March 7, 2018

Re: Wrangell Byford Junkyard Cleanup

**Figure 5. Monofill cover & cap designs.** (Left) Cover design described in the January 2017 Ahtna Engineering report. (Below) Cover design described in the May and June 2017 E&E reports.

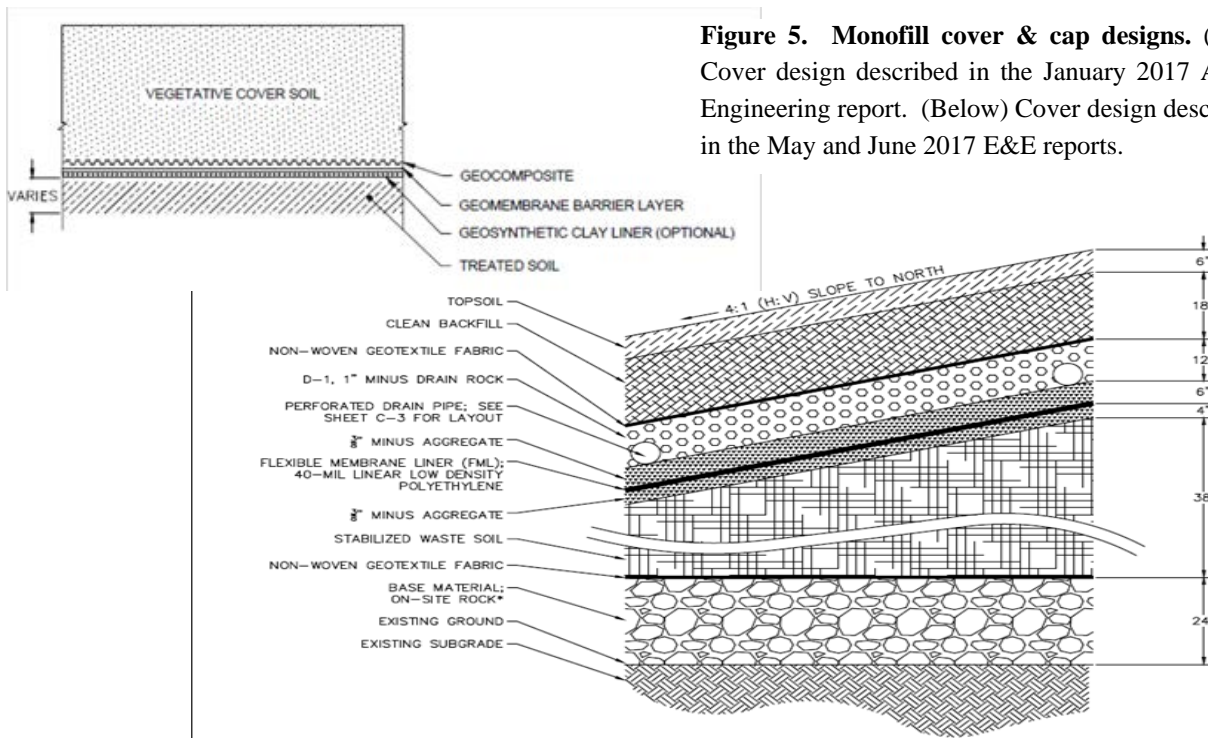
The actual design of the monofill is good, although there is incomplete information on the seepage that each cover design would allow to infiltrate into treated soil. By law, a cover needs to minimize water infiltration.<sup>17</sup> Two cap & cover designs were described:

January 2017 Ahtna report described the cap as consisting, from the soil up, of a geosynthetic clay liner (GCL) covered with a 60 mil HDPE liner, with geotextile above that and topped with two feet of soil that would be vegetated. The clay and HDPE liners limit water from reaching the soil; vegetation acts to prevent erosion and provide evapotranspiration for some of the rain and snow. A detailed infiltration analysis was conducted. The cover with the GCL should only allow about one gallon of surface water per acre per year to infiltrate into the treated soil; however if the

GCL is not used, the infiltration could be around 280 gallons per acre per year. HDPE liners are rolls of material welded together at the seams; they perform best when there are no gaps, tears, or cracks, which in turn require folds and wrinkles in the rolls to be smoothed.

The May 2017 E&E Design report<sup>18</sup> has replaced the geosynthetic clay liner with four inches of 3/8" aggregate, and replaces the 60 mil HDPE with a thinner 40 mil LLDPE barrier. It adds perforated drainage pipe embedded in another layer of 3/8" aggregate and D-1 drain rock. It keeps the upper layer of geotextile and soil with vegetation. The E&E report states that the 40 mil LLDPE barrier "will easily meet" the legal requirements for limiting infiltration<sup>19</sup> but there is no clear table describing seepage rates as there was in the Ahtna report. The detailed infiltration analysis appears to have been done for uncovered soil with a result of 780 gallons per acre infiltrating per *day*, or 72,200 gallons per acre per year. The attachment with outputs of the infiltration model was not accompanied by a clear table of results that the layman could understand.

Two covers were discussed in documents. Essentially DEC appears to have replaced the GCL barrier of the 2017 Ahtna report with a drainage pipe and the HDPE barrier with a more flexible LLDPE barrier that is less susceptible to cracks and tears. However, it was the GCL barrier that really kept rainwater from infiltrating into the soil pile. I would think that the GCL layer tied into chimney rock would provide sufficient drainage, and do a better job of keeping water away from the treated soil. If drainage pipe provides an advantage, what would be the cost of placing both drainage pipe and GCL within the cover?

- **Recommendation.** Based on percent soil moisture and soil volume, provide information on the volume of soil porewater that could drain down after a cover is in place. Combine this information with contaminant analysis to provide a clear description of soil contaminant types and concentrations in porewater.
- **Recommendation.** Provide a simple itemized comparison of the amount of water and seepage rates that each design will allow to infiltrate into soil along with an itemized comparison of the costs.

**Figure 7. Monofill drainage design.** From E&E 2017.

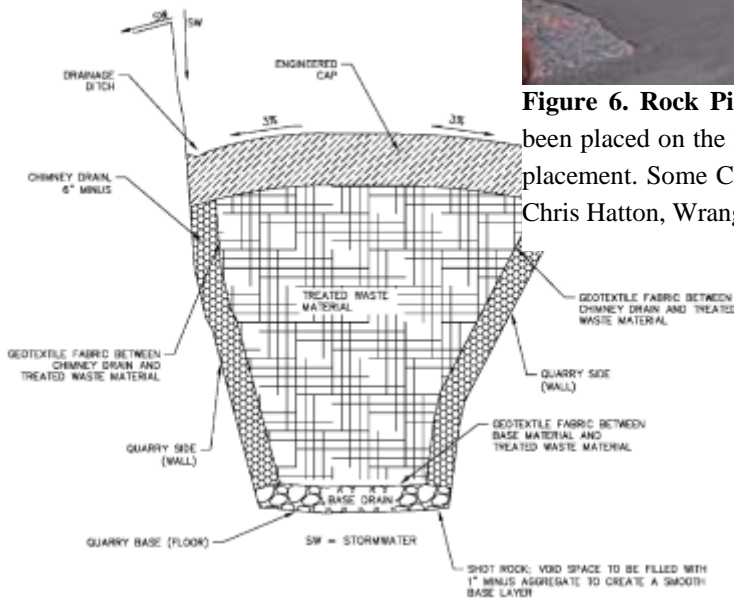
The design does not include a liner or a liner/leachate system. The cost for such a system is minimal, about \$135,000.<sup>22</sup> The reasons for not incorporating this in the design were that a liner would collect water and be subject to freeze-thaw action that could cause cracking and leakage, and a liner/leachate system would require thousands of feet of pipe to collect the leachate. The design without the liner/leachate system was expected to allow

water quality sampling at the location where the chimney drain/French drain system discharges, and groundwater could be sampled at the monitoring well at the head of the quarry. The location and design of the discharge outlet was not available in the E&E Basis of Design report but a drawing was available in the 2017 Nortech report (see attachment 2), along with some photos.

The monofill is designed to direct stormwater runoff off the cover into a French drain that would split, with drainage apparently discharging near the mouth of the quarry and through a culvert on the opposite side of Pat’s Creek Road.<sup>25</sup> This information is provided in a single figure in the Monofill Baseline Sampling report; site inspection and Basis of Design drawings provide no information on the final outfall for drainage. There is no estimate of the monthly or seasonal drainage flow at the outfall in any documents I reviewed.

There are mitigation options that do not seem to have been explored. For example at Rock Pit #2, with or without a liner and leachate collection system, could drainage be directed to a collection pond with a spillway, which could provide a location for testing and a controlled location where water could be stored for treatment or be re-directed away from surface water if phosphate levels increased?

- **Recommendation.** Provide mitigation options to control, treat, or divert seepage if contaminant levels increase at testing locations.
